Chaity Composite Ltd. (Extension 2)

Chotto Shilmondi, Tripurdi, Sonargaon, Narayanganj

22 February 2024

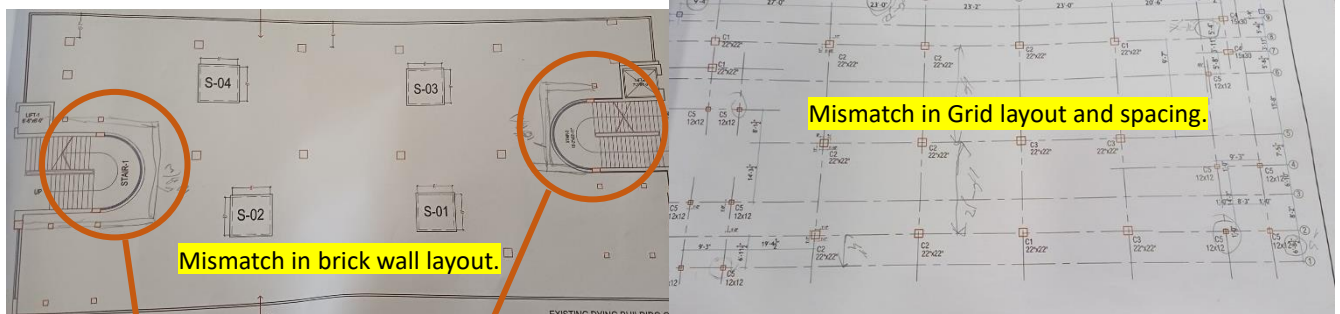
Observation-2: Discrepancies in as-built drawings (Building 01).

Brick wall was observed in marked position at 1st floor level which was not shown in as built drawing.

Mismatch was observed in column grid spacing. Cantilever portion at side was observed 2.4m instead of 1.62m.

Description: During the inspection, discrepancies were observed between the as-built drawing and

the on-site condition. Mismatches are shown above. The building engineer is required to survey the whole structure and update the drawing reflecting on-site conditions.

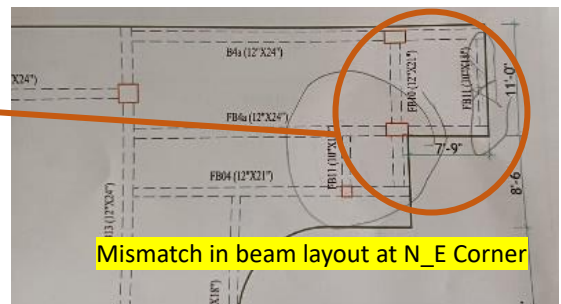
Beam is not passing through column. Also, edge beam is found missing.

Observation 4: Mismatch in as-built drawings. (Building-02)

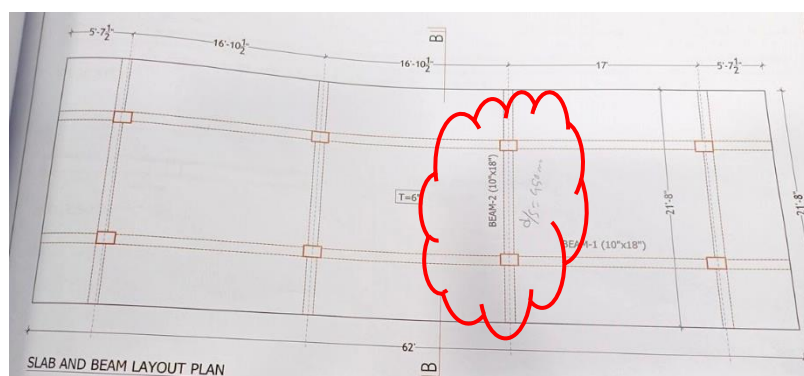
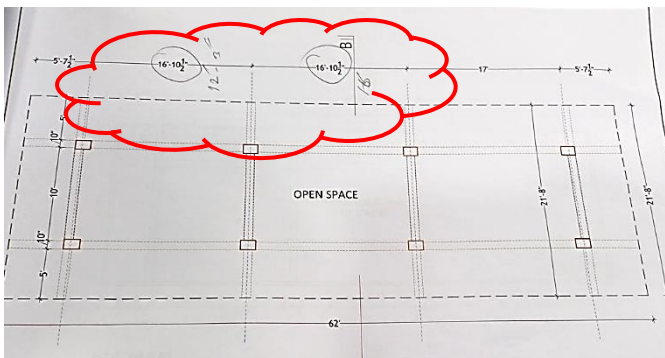
Description: Mismatches were found in as-built drawing of grid spacing, floor height & beam sizes. During inspection, beam size found 10X24" instead of 10X18" and ground floor height found 14'9" instead of 12'. The building engineer is required to revise the as-built drawing as per actual site condition.

Observation 5: Corrosion on steel members (Building-06)

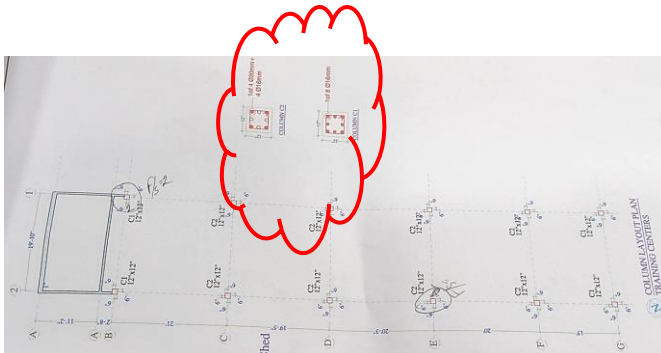
Description: Corrosion was found on steel members at several locations. The building engineer is required to remove corrosion and provide rust-proof paint on steel members.

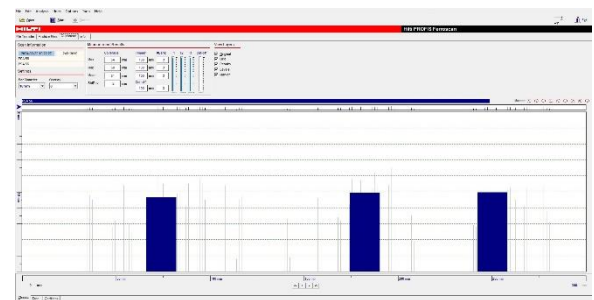
6-Nos rebar found instead
of 8-Nos bar

Description: Mismatches were found in the as-built drawing of column rebar and no details of roof steel members were found. During inspection, 6-nos column rebar was found instead of 8-nos rebar. The building engineer is required to revise the as-built drawing as per the actual site condition.

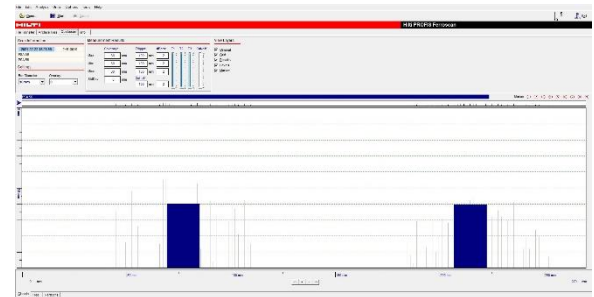
No details found of Steel
members in as built
drawing.
